PRODUCT/PROCESS CHANGE NOTICE (PCN)

PCN #: **TB1503-01 (R1)** DATE: **October 23, 2015**
 Product Affected: **TSSOP-20, TSSOP-24, TSSOP-28,
 TSSOP-48, TSSOP-56, TVSOP-48
 SOIC-28, SSOP-20, SSOP-28,**
 (Refer to Attachment II for affected part# shipped in Reel)
 Date Effective: **February 1, 2016 Earliest Date - Refer to
 specific date by package type**

ATTACHMENT I - PCN #: TB1503-01 (R1)

Figure 1: Additional Label pasted on ESD/Moisture barrier bag and Pizza box

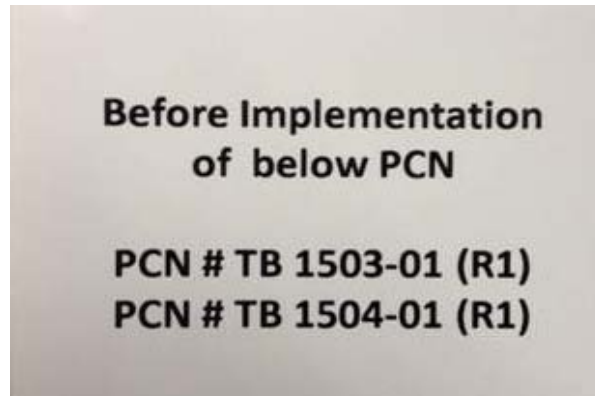
Customers may expect to receive shipments of products in new packing no sooner than 90 days from the date of this PCN notification. Shipments to customers may contain products shipped with either the existing packing or new packing during the transition period. Shipments made in the existing packing after the PCN becomes effective will have an additional label pasted on the ESD/moisture barrier bag and pizza box.

Illustration of Carrier Tape Pocket Design Change

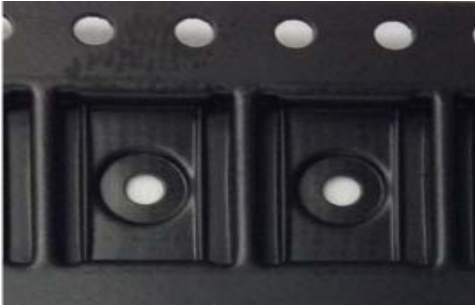
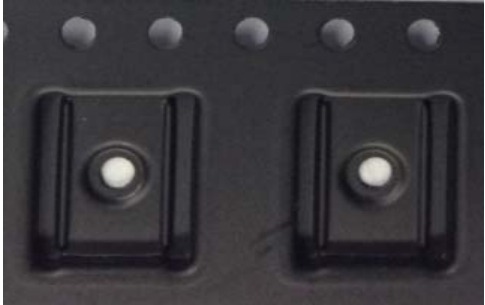
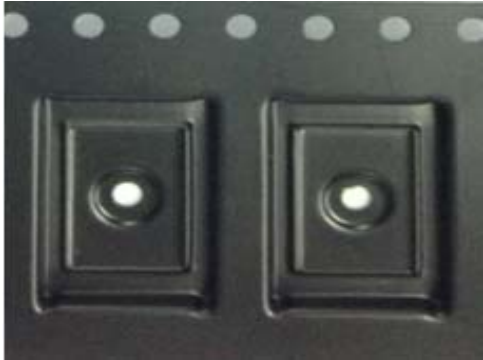
Package	From	To
TSSOP-20	Carrier Tape Part# P8-464-000 	Carrier Tape Part# P8-291-P20 
TSSOP-24	Carrier Tape Part# P8-329-P24 	Carrier Tape Part# P8-169-P24 
TSSOP-48	Carrier Tape Part# P8-260-P48 	Carrier Tape Part# P8-324-P48

Description	From	To
IDT Carrier Tape Part#	P8-464-000	P8-291-P20
IDT Carrier Tape Drawing#	MSC-7521	MSC-7519
Supplier Carrier Tape Part#	PGG20-20B3-360C-SD	eCA1760-PS-BLK-350
Supplier	PCT	E-PAK
Pocket Width, Ao (mm)	7.15 ± 0.05	7.00 ± 0.10
Pocket Length, Bo (mm)	6.90 ± 0.05	7.00 ± 0.10
Pocket Depth, Ki (mm)	1.25 ± 0.05	1.30 ± 0.10
Pocket Pitch, P1 (mm)	12.0 ± 0.1	8.0 ± 0.1
Total Pocket Depth, Ko (mm)	1.55 ± 0.05	1.60 ± 0.10
Carrier Tape Width, W (mm)	16.0 +0.2/-0.1	16.0 +0.2/-0.1
Carrier Tape Thickness, T (mm)	0.30 ± 0.05	0.30 ± 0.05

Description	From	To
IDT Carrier Tape Part#	P8-329-P24	P8-169-P24
IDT Carrier Tape Drawing#	MSC-5914	MSC-3388
Supplier Carrier Tape Part#	TSSOP24L-20B3-360C-SD	TSS30P12GP-20B3-360-SD
Supplier	PCT	PCT
Pocket Width, Ao (mm)	6.85 ± 0.10	7.00 ± 0.10
Pocket Length, Bo (mm)	8.20 ± 0.10	8.20 ± 0.10
Pocket Depth, Ki (mm)	1.40 ± 0.10	1.30 ± 0.10
Pocket Pitch, P1 (mm)	8.00 ± 0.10	12.00 ± 0.10
Total Pocket Depth, Ko (mm)	1.70 ± 0.10	1.55 ± 0.10
Carrier Tape Width, W (mm)	16.0 +0.2/-0.1	16.0 +0.2/-0.1
Carrier Tape Thickness, T (mm)	0.30 ± 0.05	0.30 ± 0.05

Description	From	To
IDT Carrier Tape Part#	P8-260-P48	P8-324-P48
IDT Carrier Tape Drawing#	MSC-7388	MSC-7539
Supplier Carrier Tape Part#	TSS48P16GP-22B3-360C-SD	eCA1765-PS-BLK-350
Supplier	PCT	E-PAK
Pocket Width, Ao (mm)	8.45 ± 0.13	8.85 ± 0.10
Pocket Length, Bo (mm)	13.00 ± 0.13	12.90 ± 0.10
Pocket Depth, Ki (mm)	1.20 ± 0.10	1.30 ± 0.10
Pocket Pitch, P1 (mm)	16.00 ± 0.10	12.00 ± 0.10
Total Pocket Depth, Ko (mm)	1.60 ± 0.10	1.50 ± 0.10
Carrier Tape Width, W (mm)	24.0 +0.2/-0.1	24.0 +0.2/-0.1
Carrier Tape Thickness, T (mm)	0.30 ± 0.05	0.30 ± 0.05

Illustration of Carrier Tape Pocket Design Change

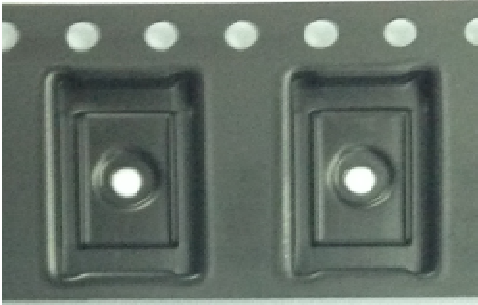
Package	From	To
SOIC-28	Carrier Tape Part# P8-187-S28 	Carrier Tape Part# P8-370-P28 
TSSOP-28 and TVSOP- 48	Carrier Tape Part# P8-145-PF8 	Carrier Tape Part# P8-330-P48 
TSSOP-56	Carrier Tape Part# P8-261-P56 	Carrier Tape Part# P8-314-P56

Description	From	To
IDT Carrier Tape Part#	P8-145-PF8	P8-330-P48
IDT Carrier Tape Drawing#	MSC-3196	MSC-5915
Supplier Carrier Tape Part#	TSS28/38GP-22B3-120-SD	TSSOP48LGP-22B7-120C-SD
Supplier	PCT	PCT
Pocket Width, Ao (mm)	6.90 ± 0.13	7.10 ± 0.10
Pocket Length, Bo (mm)	10.10 ± 0.13	10.10 ± 0.10
Pocket Depth, Ki (mm)	1.30 ± 0.10	1.30 ± 0.10
Pocket Pitch, P1 (mm)	12.00 ± 0.10	12.00 ± 0.10
Total Pocket Depth, Ko (mm)	1.50 ± 0.10	1.50 ± 0.10
Carrier Tape Width, W (mm)	16.00 ± 0.30	24.0 +0.2/-0.1
Carrier Tape Thickness, T (mm)	0.30 ± 0.05	0.30 ± 0.05

Description	From	To
IDT Carrier Tape Part#	P8-261-P56	P8-314-P56
IDT Carrier Tape Drawing#	MSC-7398	MSC-7543
Supplier Carrier Tape Part#	PA56SGP-22B3-360C-SD	eCA1764-PS-BLK-350
Supplier	PCT	E-PAK
Pocket Width, Ao (mm)	8.45 ± 0.13	8.85 ± 0.10
Pocket Length, Bo (mm)	14.50 ± 0.13	14.60 ± 0.10
Pocket Depth, Ki (mm)	1.20 ± 0.13	1.30 ± 0.10
Pocket Pitch, P1 (mm)	16.00 ± 0.10	12.00 ± 0.10
Total Pocket Depth, Ko (mm)	1.60 ± 0.13	1.50 ± 0.10
Carrier Tape Width, W (mm)	24.0 ± 0.3	24.0 +0.2/-0.1
Carrier Tape Thickness, T (mm)	0.30 ± 0.05	0.30 ± 0.05

Description	From	To
IDT Carrier Tape Part#	P8-187-S28	P8-370-P28
IDT Carrier Tape Drawing#	MSC-3405	MSC-5938
Supplier Carrier Tape Part#	SO28NP-22B3-75C-SD	SO28W32-22B3-62C-SD
Supplier	PCT	PCT
Pocket Width, Ao (mm)	10.80 ± 0.10	10.90 ± 0.10
Pocket Length, Bo (mm)	18.55 ± 0.10	18.55 ± 0.10
Pocket Depth, Ki (mm)	2.60 ± 0.10	2.70 ± 0.10
Pocket Pitch, P1 (mm)	12.00 ± 0.10	16.00 ± 0.10
Total Pocket Depth, Ko (mm)	3.00 ± 0.10	3.10 ± 0.10
Carrier Tape Width, W (mm)	24.0 ± 0.3	32.0 ± 0.3
Carrier Tape Thickness, T (mm)	0.30 ± 0.05	0.30 ± 0.05

Illustration of Carrier Tape Pocket Design Change

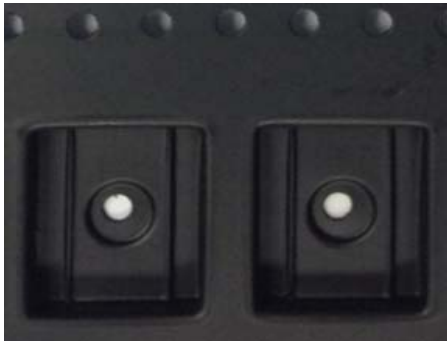
Package	From	To
SSOP-20	Carrier Tape Part# P8-259-P20 	Carrier Tape Part# P8-320-P20 
SSOP-28	Carrier Tape Part# P8-384-P28 	Carrier Tape Part# P8-321-P28

Description	From	To
IDT Carrier Tape Part#	P8-259-P20	P8-320-P20
IDT Carrier Tape Drawing#	MSC-7395	MSC-5909
Supplier Carrier Tape Part#	SSOP20SGP-22B3-360C-SD	SSOP20GP-22B3-80C-SD
Supplier	PCT	PCT
Pocket Width, Ao (mm)	8.20 ± 0.10	8.60 ± 0.10
Pocket Length, Bo (mm)	7.50 ± 0.10	7.60 ± 0.10
Pocket Depth, Ki (mm)	2.10 ± 0.10	2.00 ± 0.10
Pocket Pitch, P1 (mm)	12.00 ± 0.10	12.00 ± 0.10
Total Pocket Depth, Ko (mm)	2.50 ± 0.10	2.30 ± 0.10
Carrier Tape Width, W (mm)	16.0 ± 0.3	16.0 ± 0.3
Carrier Tape Thickness, T (mm)	0.30 ± 0.05	0.30 ± 0.05

Description	From	To
IDT Carrier Tape Part#	P8-384-P28	P8-321-P28
IDT Carrier Tape Drawing#	MSC-7356	MSC-5910
Supplier Carrier Tape Part#	EIAJ14GP-22B3-75C-SD	SSOP28W24PGP-22B3-180C-SD
Supplier	PCT	PCT
Pocket Width, Ao (mm)	8.40 ± 0.10	8.90 ± 0.10
Pocket Length, Bo (mm)	10.70 ± 0.10	10.60 ± 0.10
Pocket Depth, Ki (mm)	2.10 ± 0.10	2.00 ± 0.10
Pocket Pitch, P1 (mm)	12.00 ± 0.10	12.00 ± 0.10
Total Pocket Depth, Ko (mm)	2.40 ± 0.10	2.30 ± 0.10
Carrier Tape Width, W (mm)	16.0 ± 0.3	24.0 ± 0.3
Carrier Tape Thickness, T (mm)	0.30 ± 0.05	0.30 ± 0.05
